Technical Service Bulletin # TS85112

Recall - Emissions/Ignition System modifications TS85-112

SPECIAL SERVICE CAMPAIGN 1982 280ZX NON-TURBOCHARGED

VEHICLES REGISTERED IN CALIFORNIA

FIGURE 1

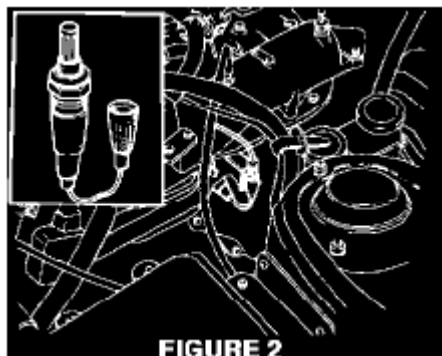
2. The dealer must install the underhood label (Figure 1) next to the existing Emission Control Information label when the correction has been completed.

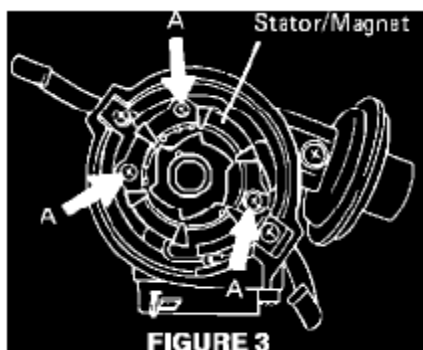
- I. Replace the exhaust gas sensor with new sensor (Figure 2).

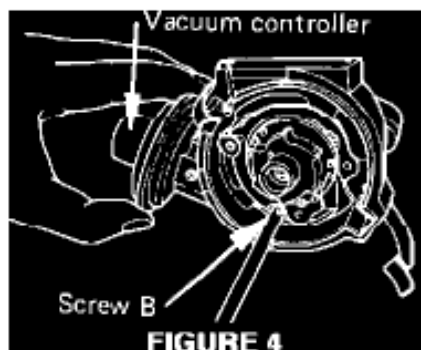
1. Disconnect the vacuum hose from the controller.
2. Remove the distributor cap.
3. Remove the rotor head.
4. Remove the three screws 'A' (Figure 3) and pull out the stator and magnet.

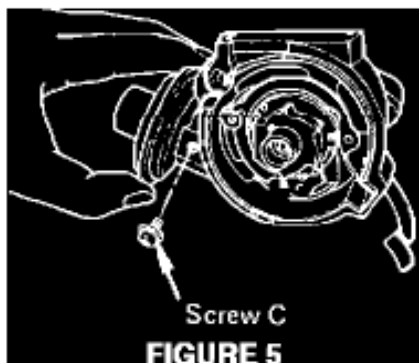
5. Remove screw 'B' which is connected to the vacuum controller (Figure 4).

CAUTION: Be careful not to drop the spring washer. When lifting screw 'B', use needle nose pliers.

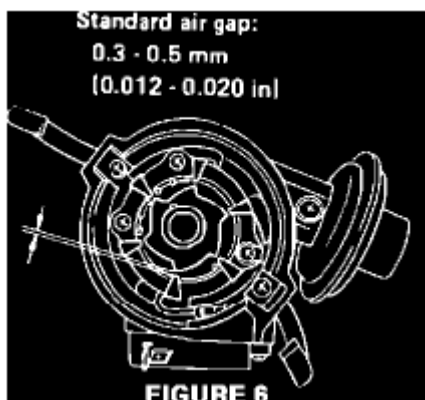
6. Remove the vacuum controller mounting screw 'C' and then pull out the vacuum controller (Figure 5).
